**U.S. NUCLEAR REGULATORY COMMISSION (NRC) REQUEST FOR ADDITIONAL
INFORMATION (RAI) REGARDING WESTINGHOUSE ELECTRIC
COMPANY (WESTINGHOUSE) TOPICAL REPORT (TR)
WCAP-17483-P/WCAP-17483-NP, REVISION 0, "WESTINGHOUSE
METHODOLOGY FOR SPENT FUEL POOL AND NEW FUEL RACK CRITICALITY
SAFETY ANALYSIS"**

ENCLOSURE 1

Figure 1: Fresh Fuel, Strong Absorbers k-eff Distribution.

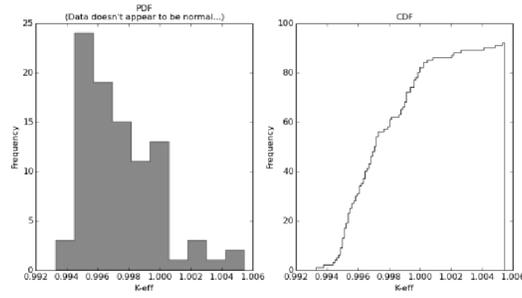
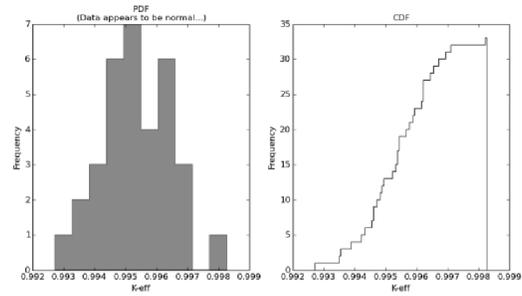
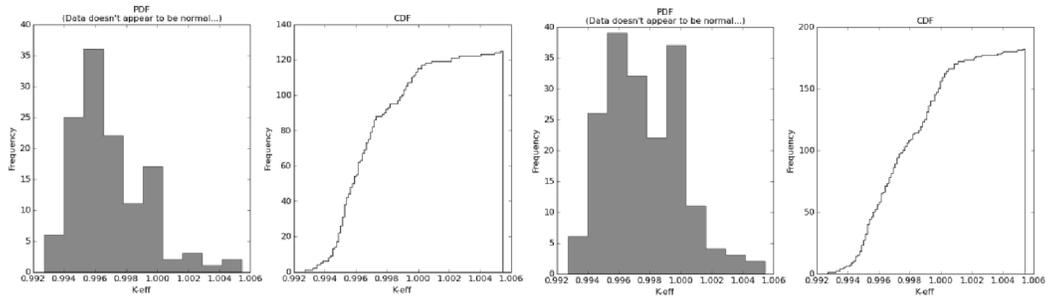
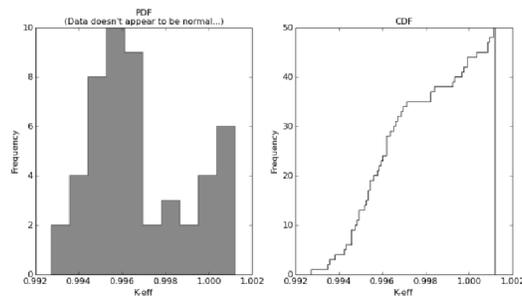
The NRC staff has performed independent confirmatory analysis to verify the results of Westinghouse's normality testing since many of the statistical formulations for calculating the bias and bias uncertainty rely on the assumption of data normality. NUREG-1475, Revision 1, "Applying Statistics," discusses the D'Agostino test for normality, which similar to the [] test, is "considered an omnibus test for normality," but is only limited to sample sizes greater than approximately 20. Other applicable normality tests were also applied (i.e., the Lilliefors and Anderson-Darling tests).

The only validation set where independent normality testing is in agreement with Westinghouse is for the fresh fuel with no strong absorbers set; visual examination provides additional evidence that this data is likely to be normally distributed (see Figure 1). For all other validation sets, there is strong evidence that these sets are not likely to be normally distributed; again, visual examination provides additional evidence supporting this finding (see Figures 2 through 4). The only test that does indicate that these sets are normally distributed is the test used by Westinghouse, which is the [] test, which is of relatively low statistical power (Reference: *Comparisons of various types of normality tests*, B. W. Yap, C. H. Sim, Journal of Statistical Computation and Simulation, Vol. 81, Iss. 12, 2011).

Revise the analysis in WCAP-17483-P/WCAP-17483-NP, Revision 0, to include a more robust data normality assessment.
